**BROWNS FERRY NUCLEAR PLANT (BFN) - UNIT 3 - AMERICAN SOCIETY OF MECHANICAL ENGINEERS (ASME) SECTION XI, INSERVICE INSPECTION (ISI) PROGRAM - REQUESTS FOR RELIEF 3-ISI-13, 3-ISI-14, AND 3-ISI-15**

REQUEST FOR RELIEF 3-ISI-13

REQUEST FOR RELIEF 3-ISI-14

REQUEST FOR RELIEF 3-ISI-15

Sketch SK-B3022

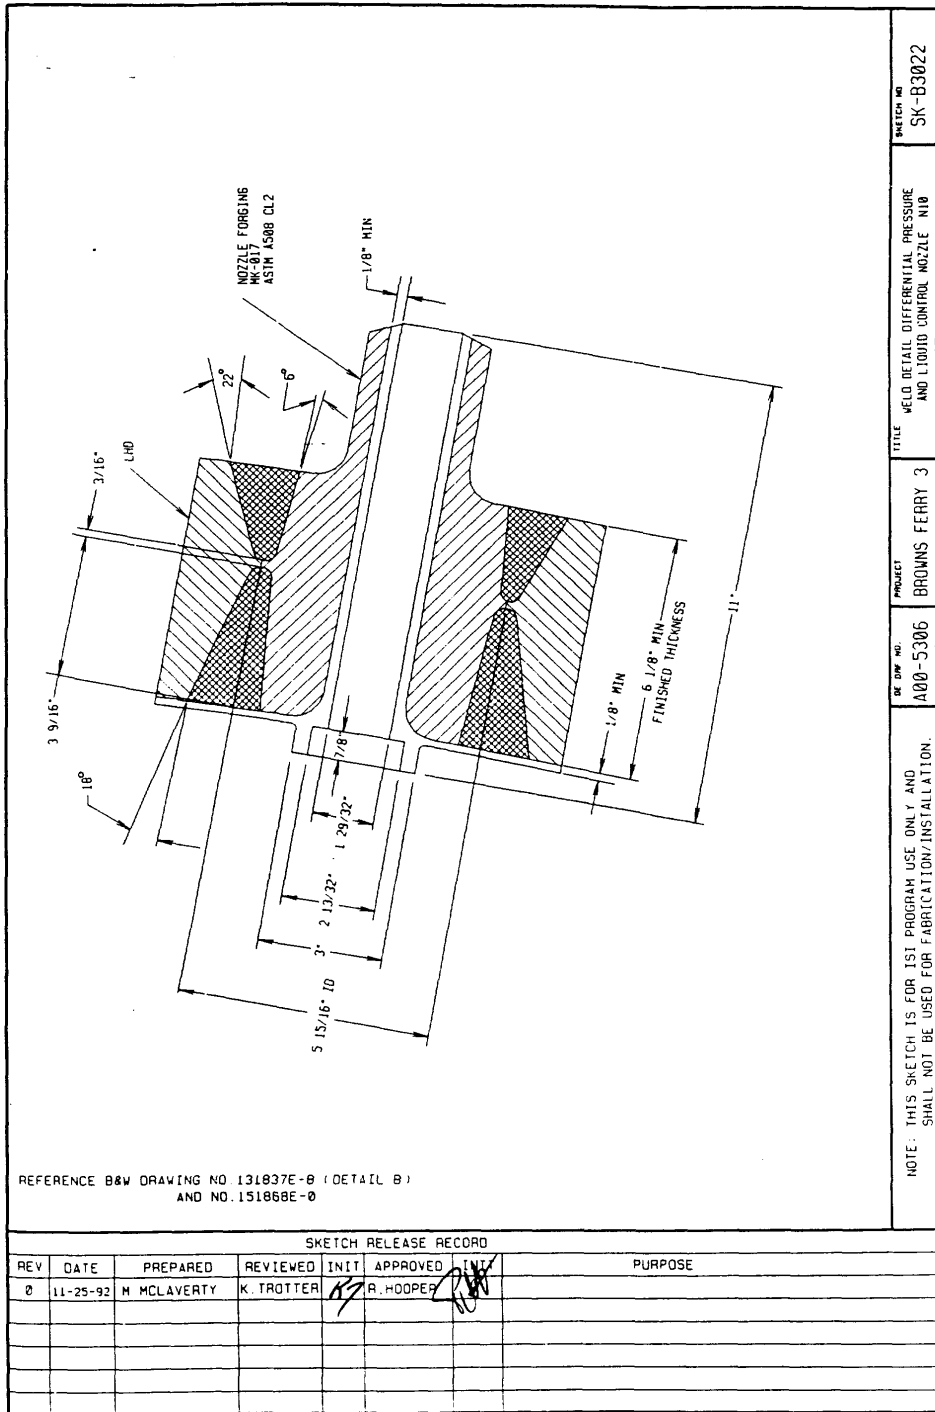
<b><u>Unit:</u></b>	Three (3)
<b><u>ISI Interval:</u></b>	ASME Section XI, Second Ten-Year ISI Interval (November 19, 1996 to November 18, 2005)
<b><u>System(s):</u></b>	Standby Liquid Control (SLC)
<b><u>Components:</u></b>	RPV Nozzle (N-10) Inside Radius Section (See Attachment, Sketch SK-B3022)
<b><u>ASME Code Class:</u></b>	ASME Code Class 1
<b><u>ASME Section XI Code Edition:</u></b>	1989 Edition, No Addenda
<b><u>Code Table:</u></b>	IWB-2500-1
<b><u>Examination Category:</u></b>	B-D, "Full Penetration Welds of Nozzles in Vessels"
<b><u>Examination Item Number:</u></b>	B3.100, "Nozzle Inside Radius Section"
<b><u>Code Requirement:</u></b>	The 1989 Edition, no Addenda, ASME Section XI, Table IWB-2500-1, Examination Category B-D, Item B3.100, requires a volumetric examination of the inside radius section of nozzles in vessels.
<b><u>Code Requirements From Which Relief Is Requested:</u></b>	Relief is requested from the requirement to perform a volumetric examination of the inside radius section of the ~2-inches diameter Standby Liquid Control nozzle.

The Standby Liquid Control nozzle is designed with an integral socket to which the boron injection piping is welded. The Standby Liquid Control nozzle is located in the bottom head of the reactor pressure vessel in an area that is inaccessible, since it is below the core shroud plate, for examination from inside of the vessel. Therefore, any examination would have to be performed from the outside surface of the vessel head. Because of the small diameter of the nozzle (i.e., ~2-inches) and the thickness of the head (i.e., ~6-inches), the ratio of the nozzle diameter to the head thickness makes it impractical to perform an examination from the nozzle-to-head radius blend surface. Also, to perform the ultrasonic examination from the head surface the sound must travel through the full thickness of the head into a complex cladding/socket configuration. These geometric and material reflectors, inherent in the design, prevent a meaningful examination from being performed on the inside radius section of the nozzle. Additionally, the inside radius section socket is welded to piping which injects boron at locations far removed from the nozzle, thus eliminating any thermal stratification possibility at the nozzle inside radius section.

The inner radius section of the SLC nozzle is required to be examined in accordance with ASME Section XI, Table IWB-2500-1, Examination Category B-D, Item B3.100 once during each Ten-Year ISI interval. The nozzle is inaccessible from inside the RPV since it is below the core shroud plate. The design configuration prevents a meaningful UT examination from being performed on the inside radius section of the SLC nozzle from outside the vessel.

TVA will perform a visual (VT-2) examination of the nozzle area each refueling outage in conjunction with the Class 1 System Leakage Test.

SKETCH NO.	SK-B3017
TITLE	WELD DETAIL RECIRCULATION OUTLET NOZZLE N1
PROJECT	BROWNS FERRY 3
DE DWG NO.	A00-5306

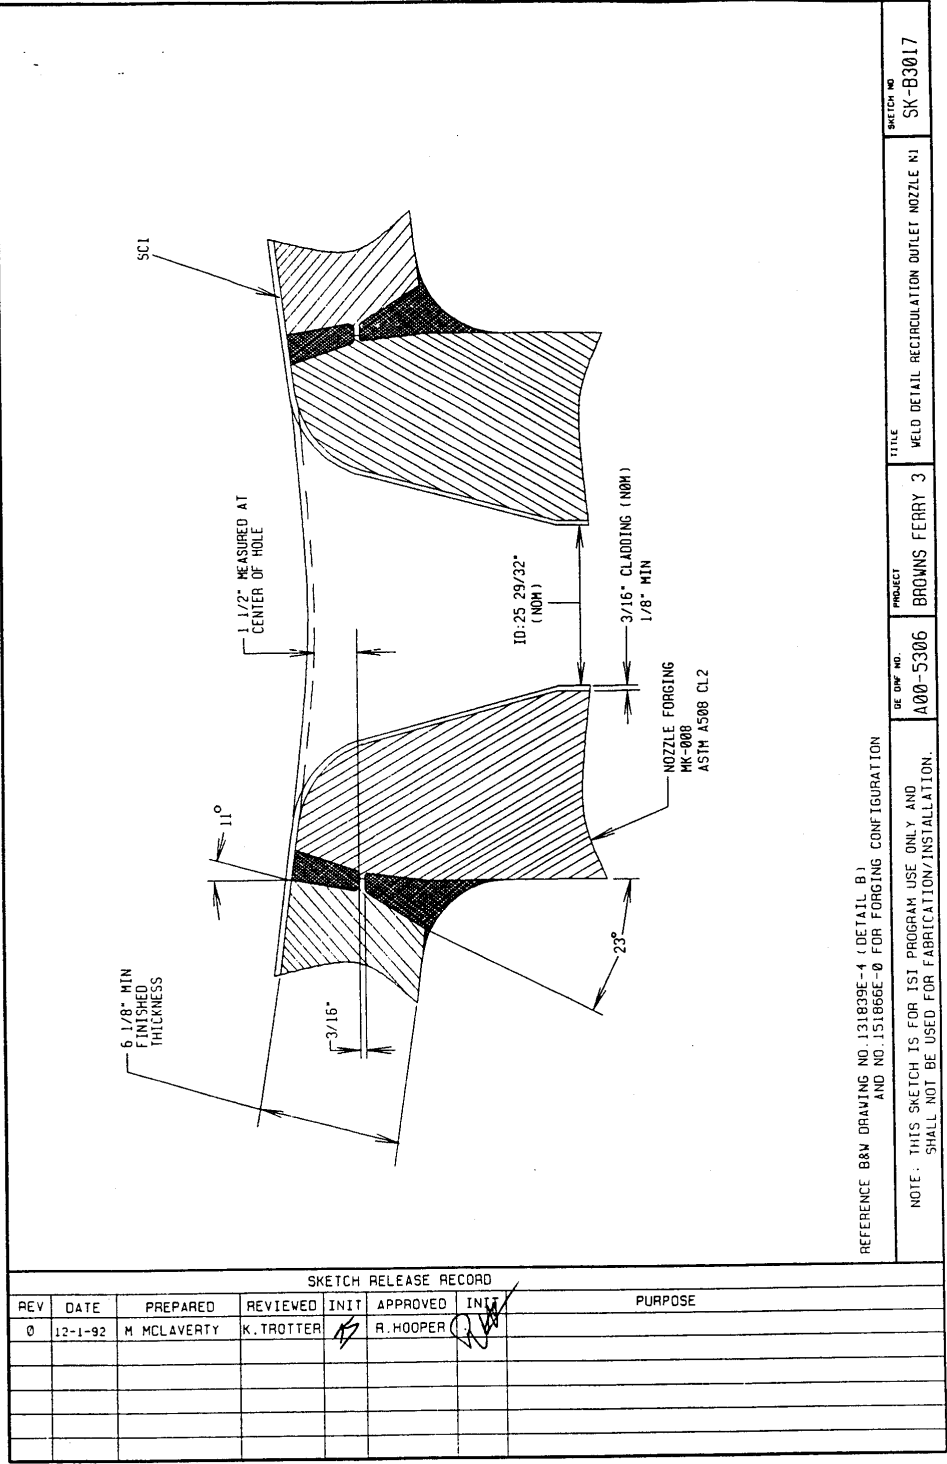
Reactor Recirculation Suction Loop Nozzles, N1A and N1B (28-inch diameter) (Total of 2 nozzles) (See Attachment A, Sketch SK-B3017)

The volumetric examinations (ultrasonic) conducted from the outside surfaces are difficult and time consuming due to the asymmetrical configuration of both the nozzle outside surface (where the transducers are manipulated) and the inner radius section of the nozzle being interrogated. Examination of the asymmetrical surfaces may require several different transducer/wedge angle combinations and these are applied at certain azimuths around the nozzle weld blend area of the vessel surface. Different size nozzles usually require a separate set of transducer/wedge angle combinations and calibrations. Several hours may be required for the calibrations and examination of a typical nozzle inner radius section.

For the Reactor pressure vessel nozzles inner radius section, (N1A, N1B, N3A, N3B, N3C, N3D, and N9), TVA will perform an enhanced remote visual examination (VT-1), capable of a 1-mil wire resolution, in accordance with ASME Section XI, VT-1 requirements. This examination will be a remote visual exam utilizing cameras. Essentially 100 percent Code coverage will be attained.

Sketch SK-B3018

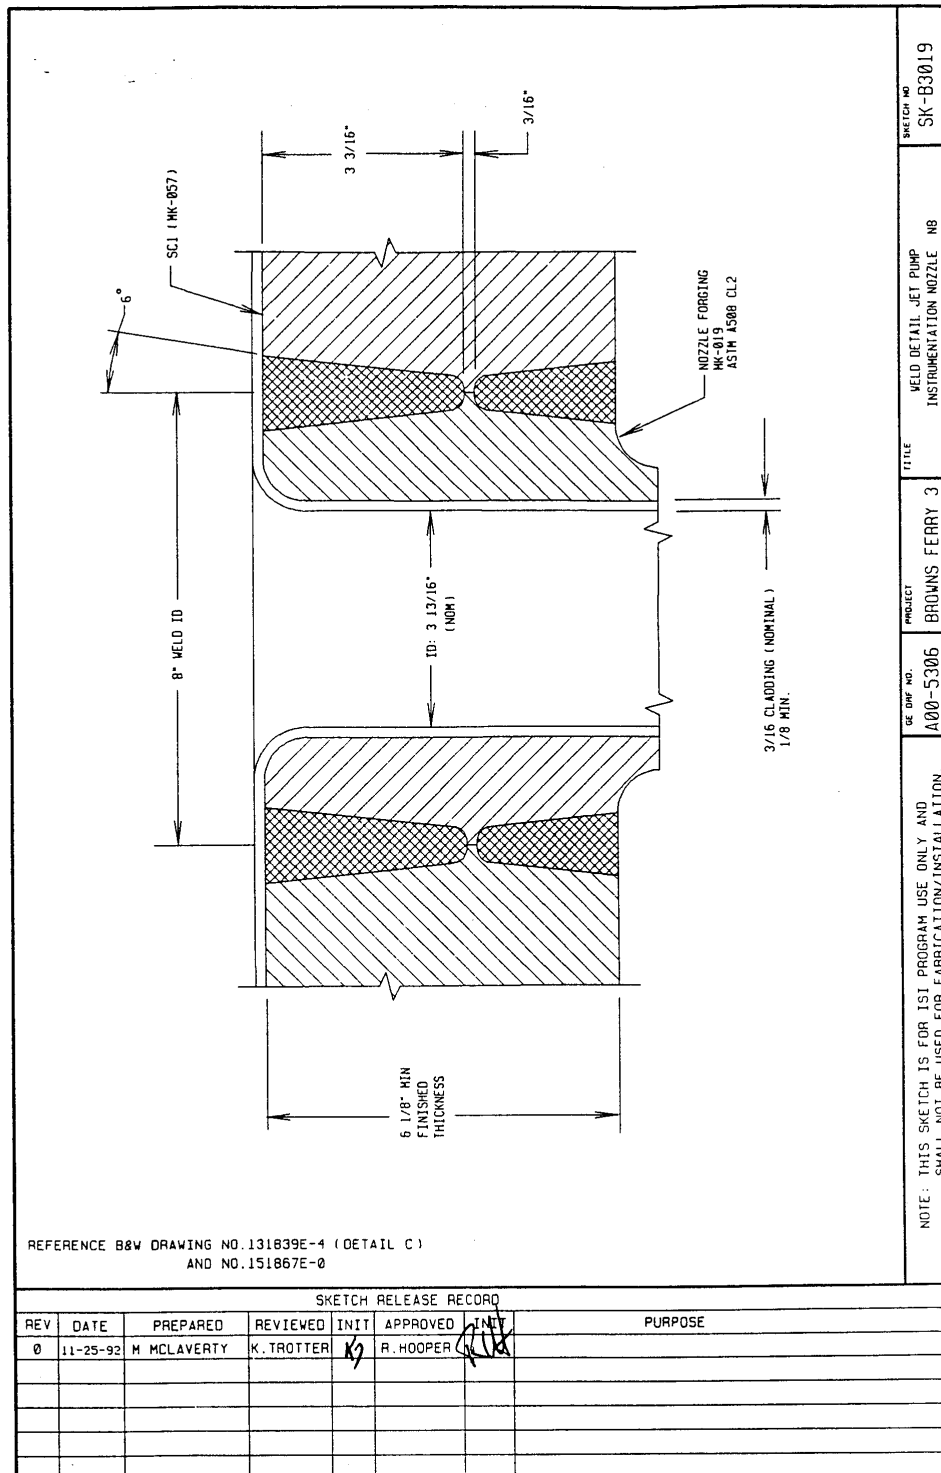
Reactor Recirculation Inlet Loop Nozzles, N2A, N2B, N2C, N2D, N2E, N2F, N2G, N2H, N2J, and N2K (12-inch diameter) (Total of 10 nozzles) (See Attachment A, Sketch SK-B3018)

Core Spray Nozzles, N5A and N5B (10-inch diameter) (Total of 2 nozzles) (See Attachment A, Sketch SK-B3018)

- N-2 nozzles (10), Recirculation Inlet - Thermal sleeve and jet pump riser piping. The inaccessible area is the inside bend radius of elbow at approximate clock positions 11:00 to 1:00, and at the bottom outside diameter bend of the elbow at approximate clock positions 5:00 to 7:00. The limitations are due to the proximity of the jet pump risers.
- N-5A and N-5B, Core Spray nozzles - Core spray thermal sleeve and tee box and feed water sparger. Feedwater spargers are located above the core spray nozzle and the configuration of the core spray thermal sleeve and tee box prohibits placement of the camera 360 degrees around the nozzle. The

limitations are at the top position at approximate clock positions 10:00 to 2:00, and the bottom position at approximate clock positions 4:00 to 8:00.

For the reactor pressure vessel nozzles inner radius section, (N2A, N2B, N2C, N2D, N2E, N2F, N2G, N2H, N2J, N2K, N5A, N5B, N8A, and N8B), TVA will perform an enhanced remote visual examination (VT-1), capable of a 1-mil wire resolution, in accordance with ASME Section XI, VT-1 requirements. This examination will be a remote visual examination from inside the vessel utilizing cameras. Visual examination of the inner radius section for the above nozzles is limited because the reactor internal piping configuration prevents placement of the camera in all positions necessary to examine the surface M-N [See Figures IWB-2500-7(a) through (d)] over the full circumference. This prevents the examination from obtaining essentially 100 percent coverage.

<u>Nozzle Type/No.</u>	<u>Estimated Coverage</u>
Recirc Inlet, N2 (10 nozzles)	50%
Core Spray, N5 (2 nozzles)	40%
Jet Pump Instrumentation, N8 (2 nozzles)	60%
